Chapter 1

Introduction to the Recirculated Portions of the Draft Environmental Impact Report

Figure 1-1.
Comparison of Estrella
Substation Fencelines,
Access Roads, and
Parcel Boundaries

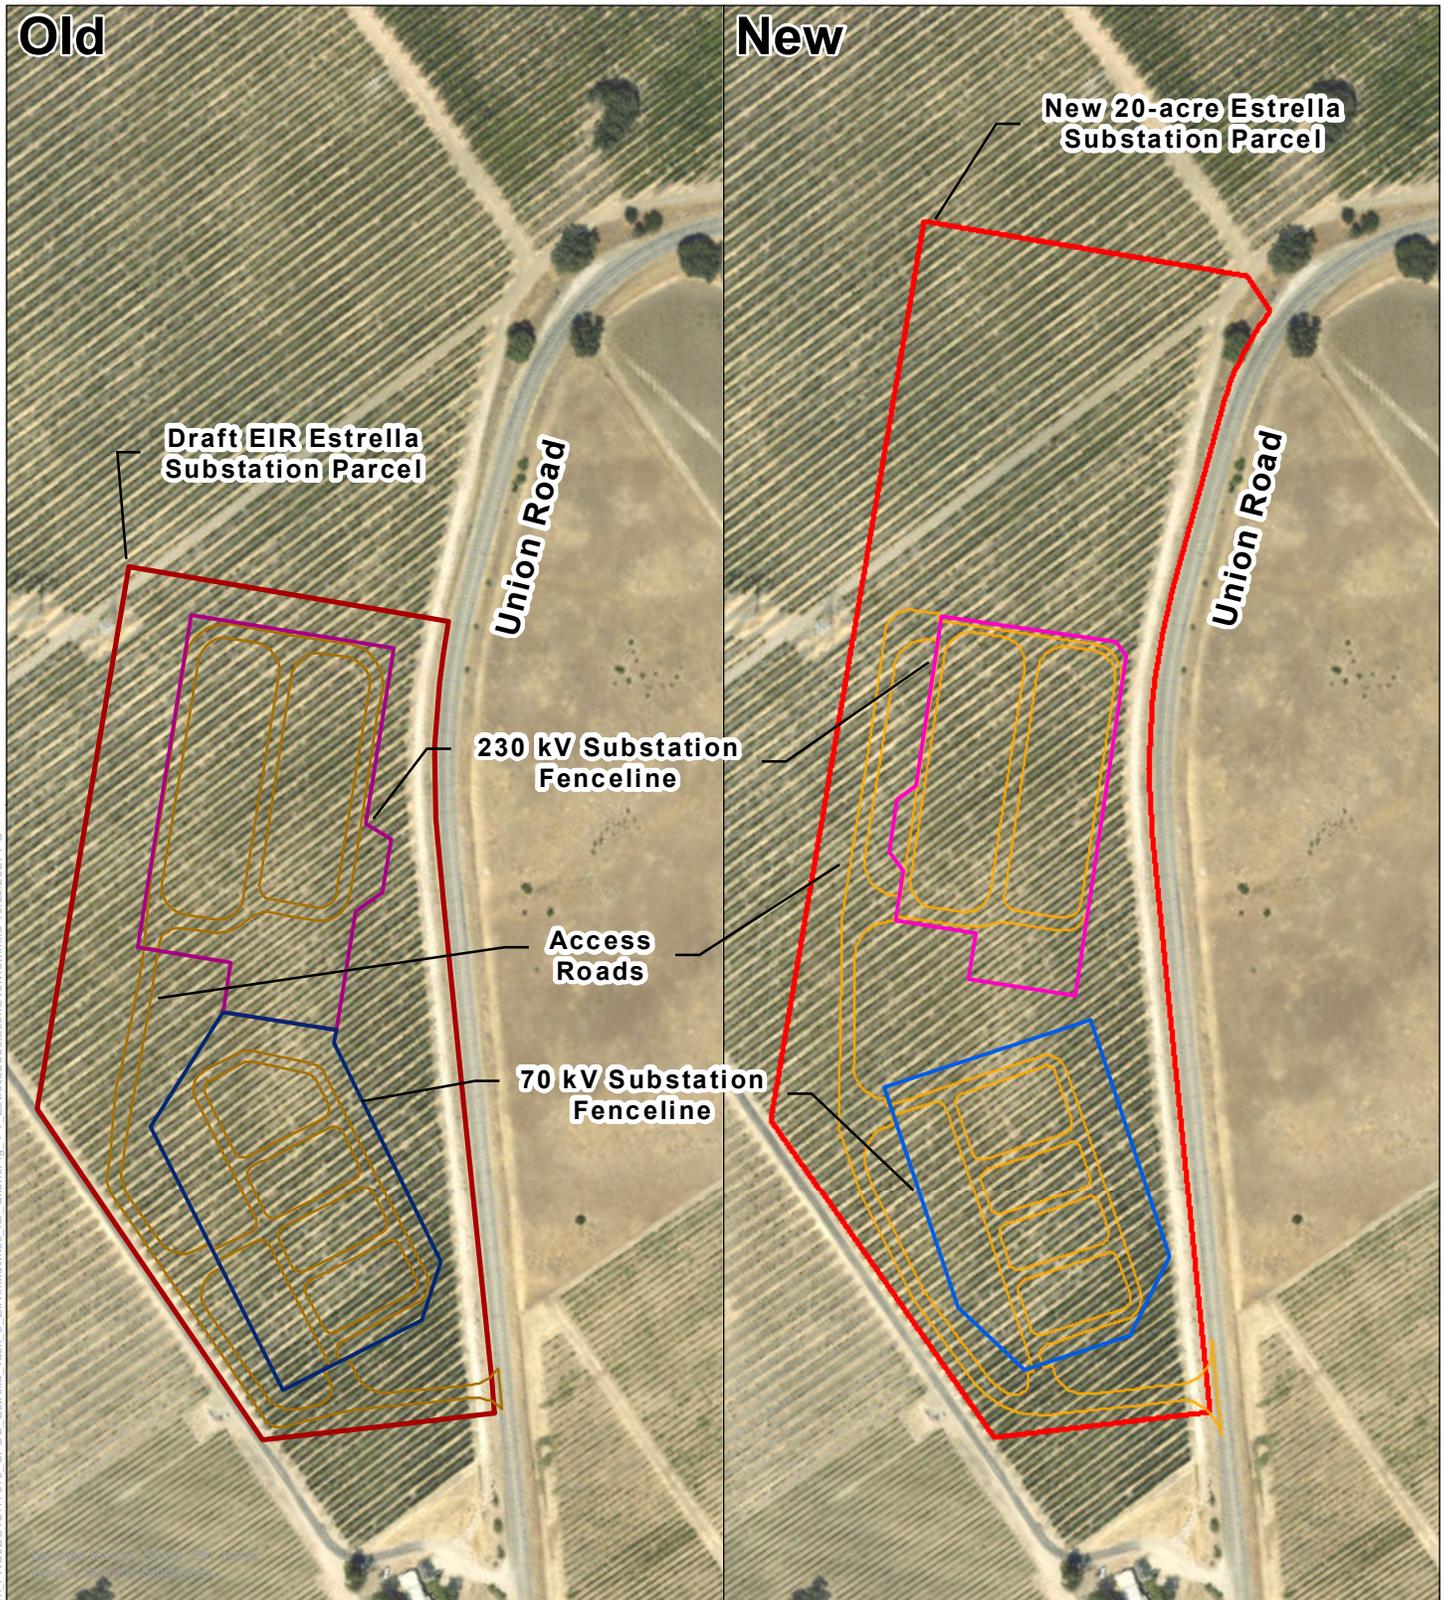
In reviewing the Proposed Project changes identified by HWT (see summary in Section 1.1.1), CPUC determined that one of these changes could substantially increase the severity of a significant impact identified in the DEIR. Specifically, the addition of the 5-acre area as part of the Estrella Substation parcel could substantially increase the severity of the Proposed Project’s effects on agricultural resources. Figure 1-1 shows a comparison of the Estrella Substation parcel boundary, as described in the DEIR, to the new substation parcel boundary identified in HWT’s comments on the DEIR.

As such, assuming that the additional 5-acre area acquired by HWT could be impacted (as stated in HWT's original comment letter), this would constitute a substantial increase in the severity of the significant and unavoidable impact to agricultural resources identified in the DEIR. Although HWT revised its comments to state that the additional 5 acres "will not be used during or following construction for any project activities" (HWT 2021b), it did not provide substantial evidence to ensure the agricultural resource will remain used for agricultural purposes. Given that the land would be owned by HWT, even if the land would not be used for utility purposes (at this time), it may be allowed to go fallow and/or may be managed in accordance with HWT's vegetation management guidelines. The continuance of farming on the parcel would be at the discretion of the former landowner (or possibly another entity) and incumbent on HWT to continue the farming agreement. Although HWT reports that an agreement has been reached with the landowner to continue farming this area, this agreement could be terminated or not renewed in the future.

If the additional 5 acres of Unique Farmland were allowed to go fallow or were otherwise no longer actively farmed, or potentially developed at some point in the future for industrial/utility uses, this would constitute a conversion of this land to non-agricultural uses, which would be a significant impact under CEQA. In particular, based on the standard applied in the DEIR with respect to agricultural resources, this would constitute a substantial worsening of the significant impact identified for Important Farmland. As a result, CPUC determined that it was necessary to recirculate the agricultural resources section of the DEIR.

With respect to the other changes identified by HWT (see Section 1.1.1), CPUC reviewed this information and determined that the changes would not substantially worsen any of the significant impacts identified in the DEIR or create any new significant impacts. The positioning of the substation facilities slightly closer to Union Road (see Figure 2 in HWT's original comment letter [HWT 2021a: Attachment 1] and Figure 1-1) would slightly increase the prominence of the facilities to motorists driving along the road, but this change would be incremental and would not substantially change the aesthetics analysis included in the DEIR.
